RADFORD ARMY AMMUNITION PLANT, VIRGINIA

Work Plan Addendum 012: Site Characterization Plan for

**SWMU 39
SWMU 48
SWMU 49
SWMU 50
SWMU 58
SWMU 59
AOC-FLFA
AOC-Building 4343
New River Unit**

Re: Radford Army Ammunition Plant
SWMUs 39, 48, 49, 50, 58, and 59
Former Lead Furnace AOC and Building 4343 AOC
New River Units
Work Plan Addendum 12
Document submittal and review

FIGURE 1.1-1

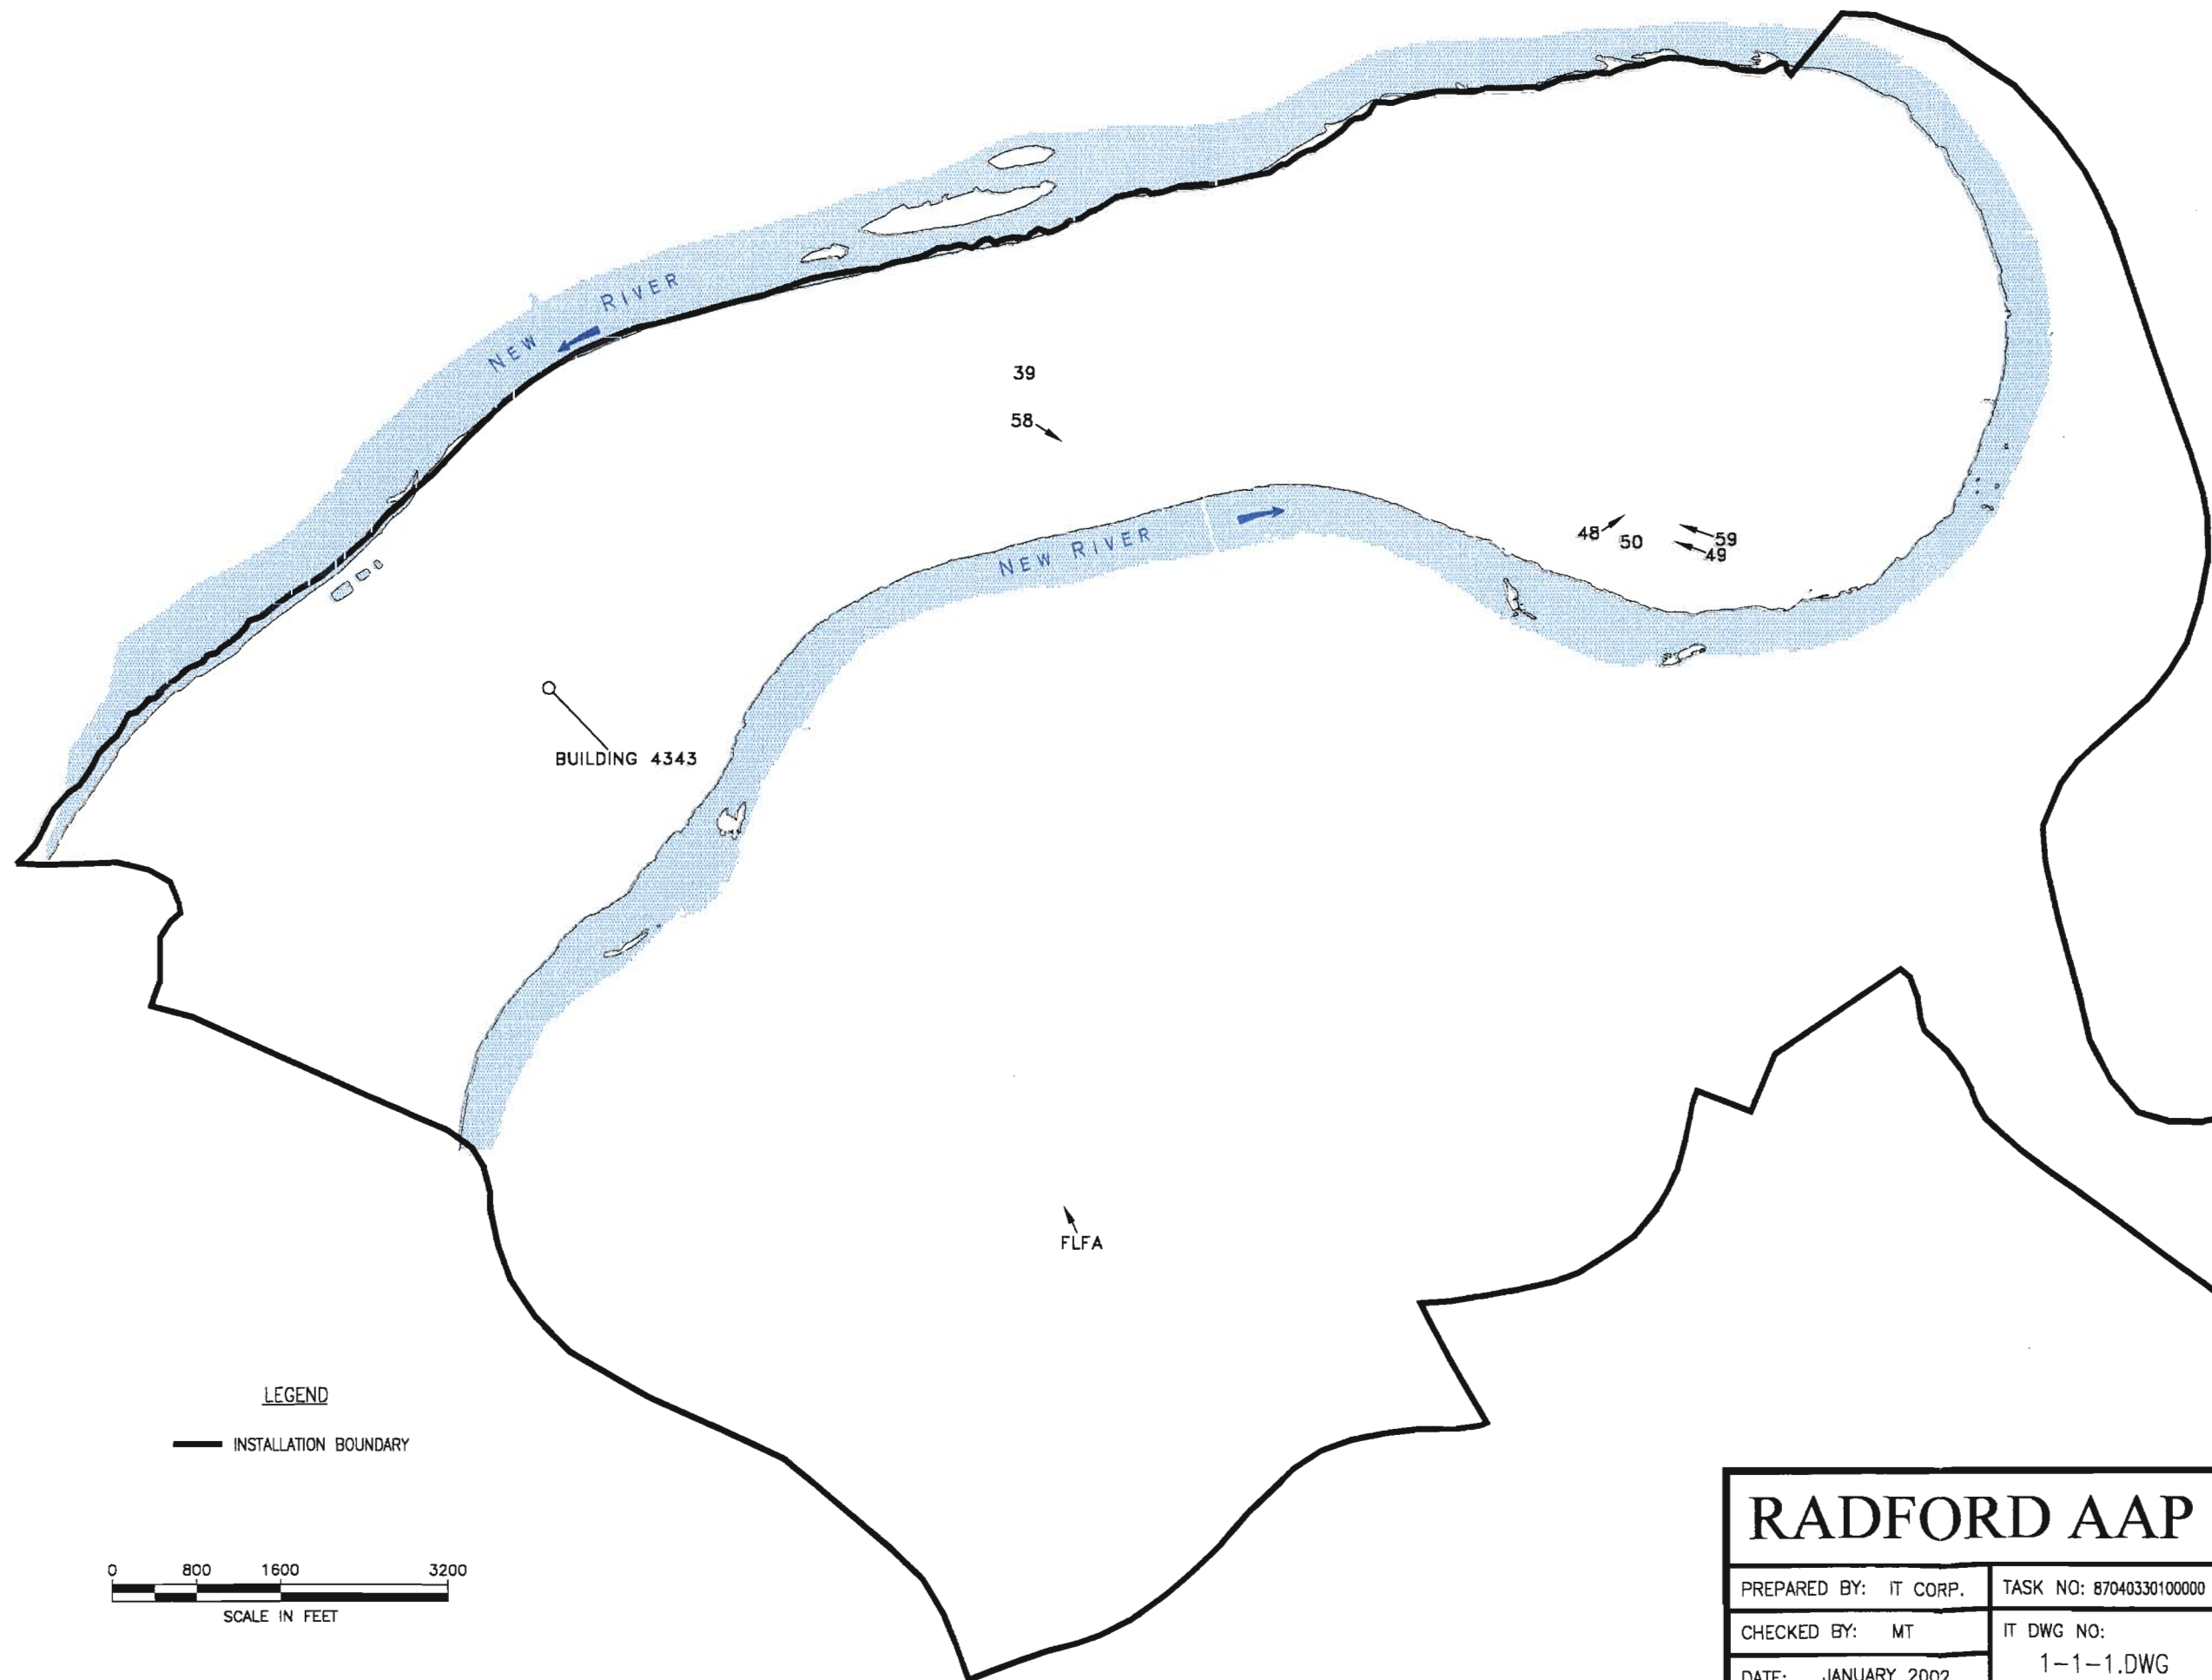
Comment: I was unable to locate SWMU-58 - Rubble Pile, AOC - Former Lead Furnace Area (FLFA) and AOC Building 4343 on Figure 1.1-1. Please provide a Site Plan, which more clearly identifies the locations of these units.

6. I was unable to locate SWMU 58 – Rubble Pile, AOC – Former Lead Furnace Area (FLFA), and AOC- Building 4343 on Figure 1.1-1. Please provide a site plan which more clearly identifies the locations of these units.

Response: Figure 1.1-1 will be revised to identify the locations of all sites in WPA 12.

FIGURE 1.6-1

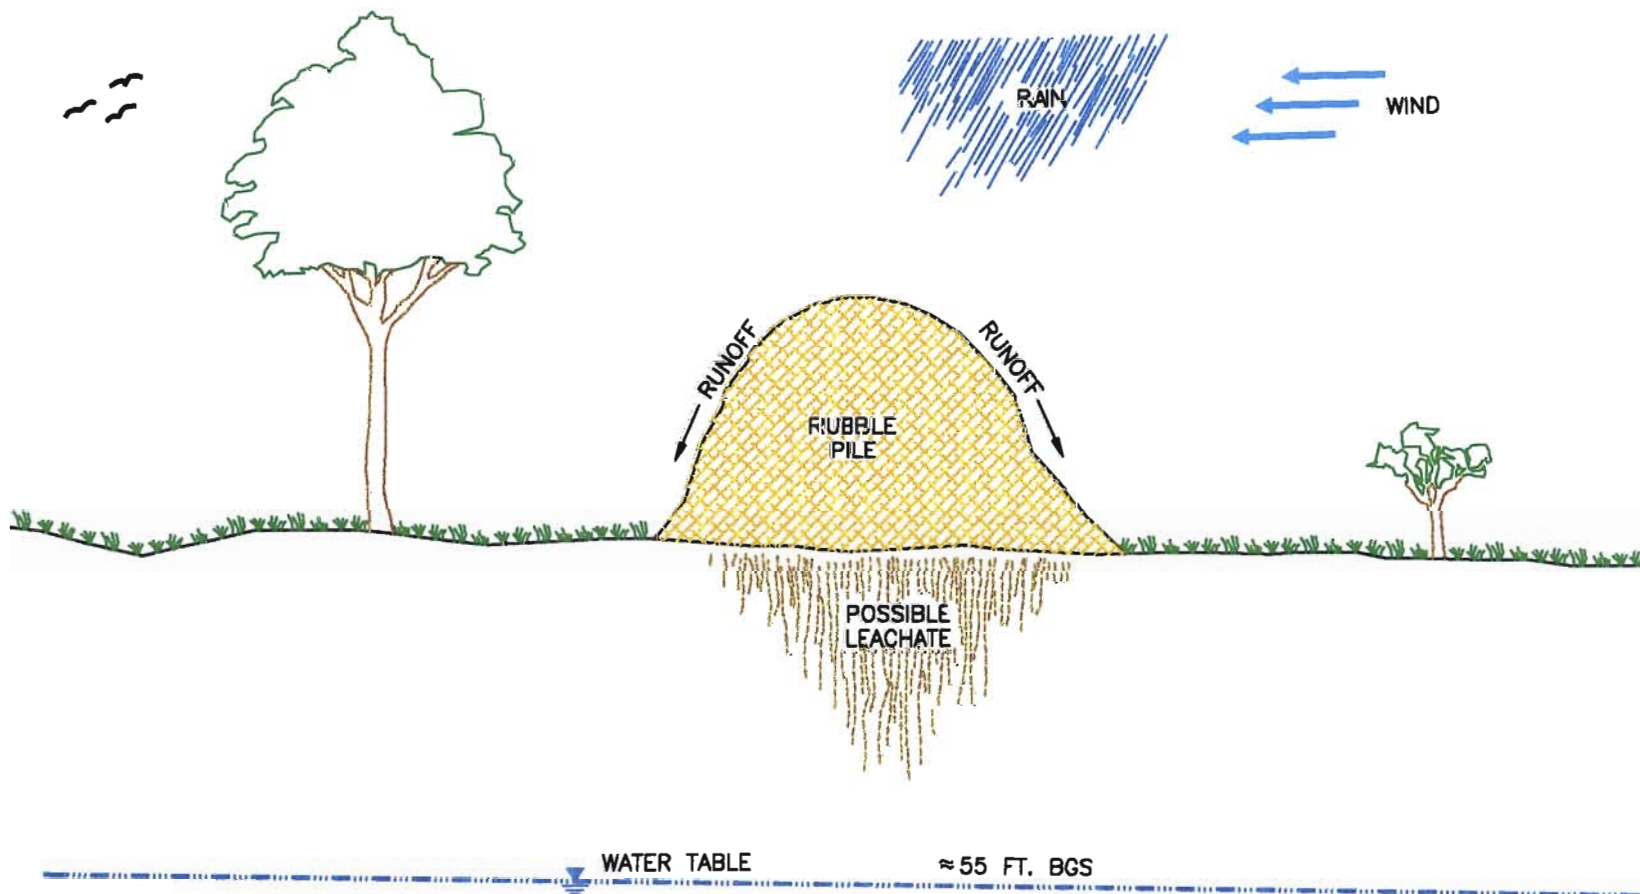
15. Section 1.6.5, Planned Field activities and Technical Approach, page 1-47: This section indicates that one surface soil sample will be collected at the southern toe of the rubble pile. Figure 1.6-3 shows the sample location (58SS05) located at the northern toe of the rubble pile. Please clarify which is correct and revise the text or figure accordingly. In addition, clarify how a single sampling location at SWMU 49 is sufficient to characterize SWMU 58 for the explosives, TCL PCBs, and dioxins/furans, considering that no previous subsurface samples with these analysis were obtained at this unit. Revise the Work Plan to provide the rationale and justification for the number and locations of samples, and propose an adequate number of sample locations for the characterization.

FIGURE 1.9-1

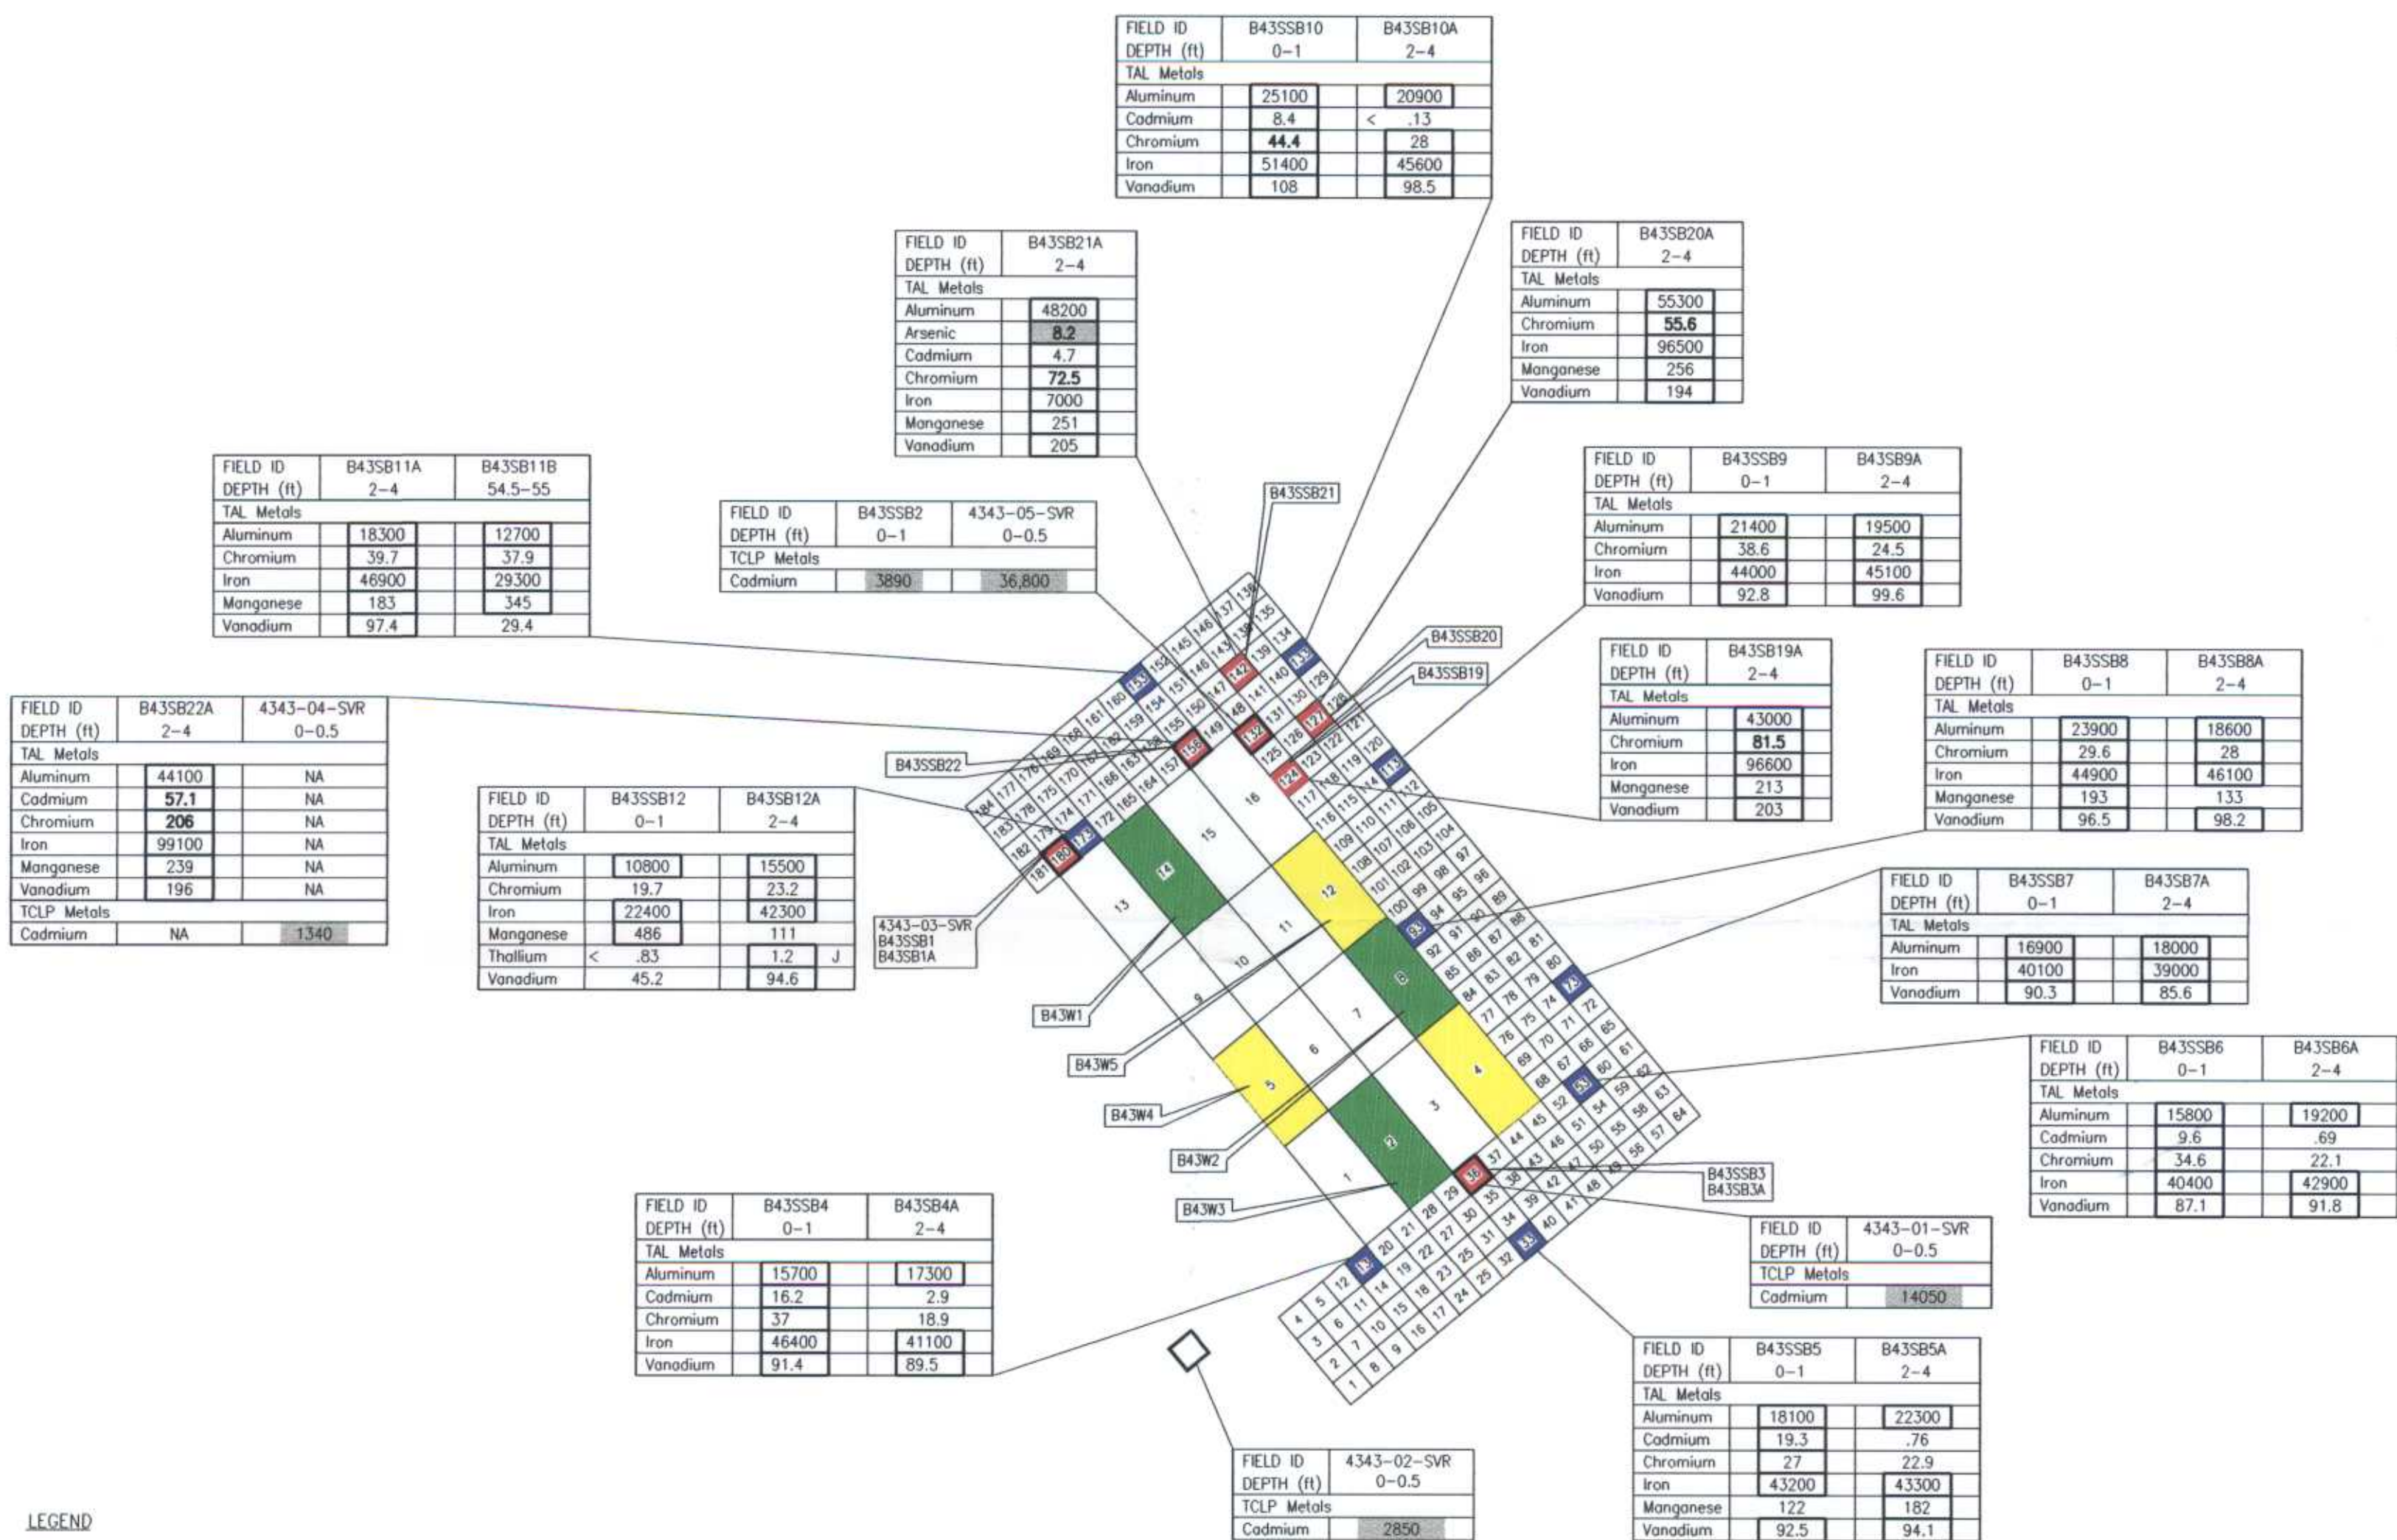
Comment: The sampling locations for all of the samples in Table A-23 are not shown on a figure. Please provide the figure with the sampling results, including 4343-02-SVR. The 1996 sampling locations should be identified on the key for Figure 1.9-1.

Comment: I was unable to locate sample B43SSB33 on either Figure 1.9-1 or Figure 1.9-2. It would be helpful if both figures had the results for each sample site by horizon. This would result in an additional two figures.

1. The sampling locations for all of the samples in Table A-23 are not shown on a figure. Please provide the figure with the sampling results, including 4343-02-SVR. The 1996 sampling locations should be identified on the key for Figure 1.9-1.
2. I was unable to locate sample B43SSB33 on either Figure 1.9-1 or Figure 1.9-2. It would be helpful if both figures had the results for each sample site by horizon. This would result in an additional two figures.
3. The lateral and vertical extent of contamination has not been delineated for the site. It appears that barium, cadmium and chromium, and possibly zinc will be the primary heavy metal COPCs. Additional sampling for TAL metals, cyanides, SVOCs, VOCs, PAHs, explosives, perchlorates, and pesticides will need to be performed for surface soils, subsurface soils at various horizons, and surface water where available.

Response: The sampling locations in Table A-23, including 4343-02-SVR, will be included on the site figure. In addition, the 1996 sampling locations will be more clearly identified on the legend for Figure 1.9-1
